PROPOSED SUBSURFACE WASTE DISPOSAL SYSTEM DETAIL SHEET

SUBDIVISION Persimmon Hill LOT 61

**NEW CENTURY HOMES  
THE JARROD  
LOT # 61 PERSIMMON HILL  
SCALE: 1"=40'**

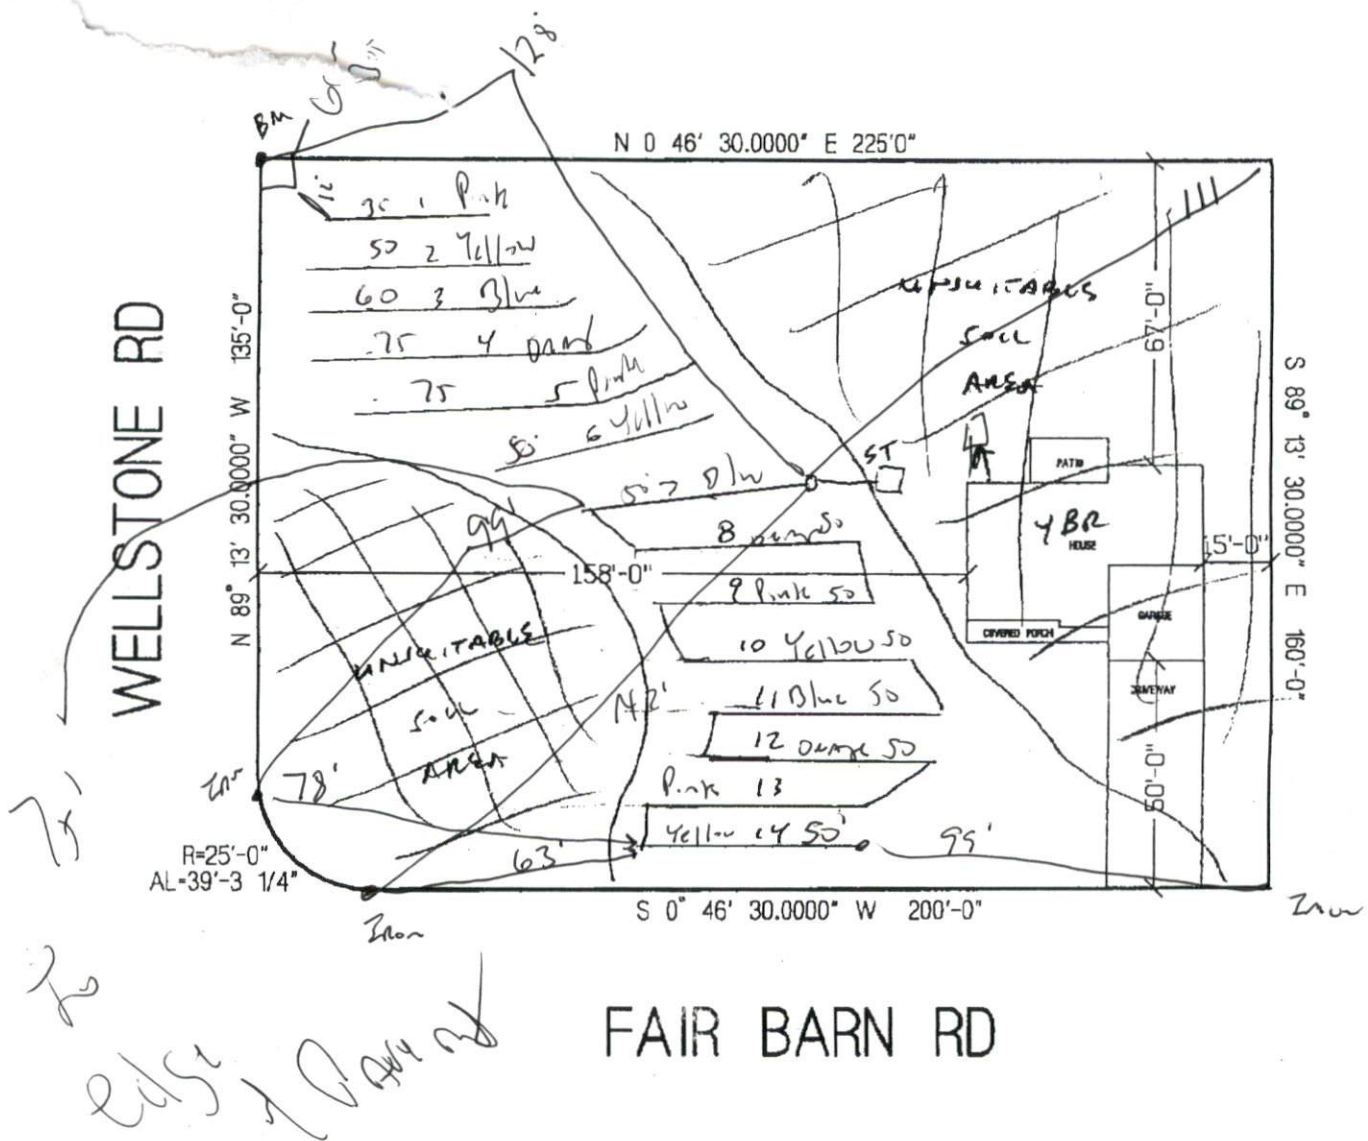
**A BEDROOM ?**

KEEPING 5 FEET FROM DRAIN LINES,  
COULD SHIFT HOUSE BACK + LEFT A LITTLE
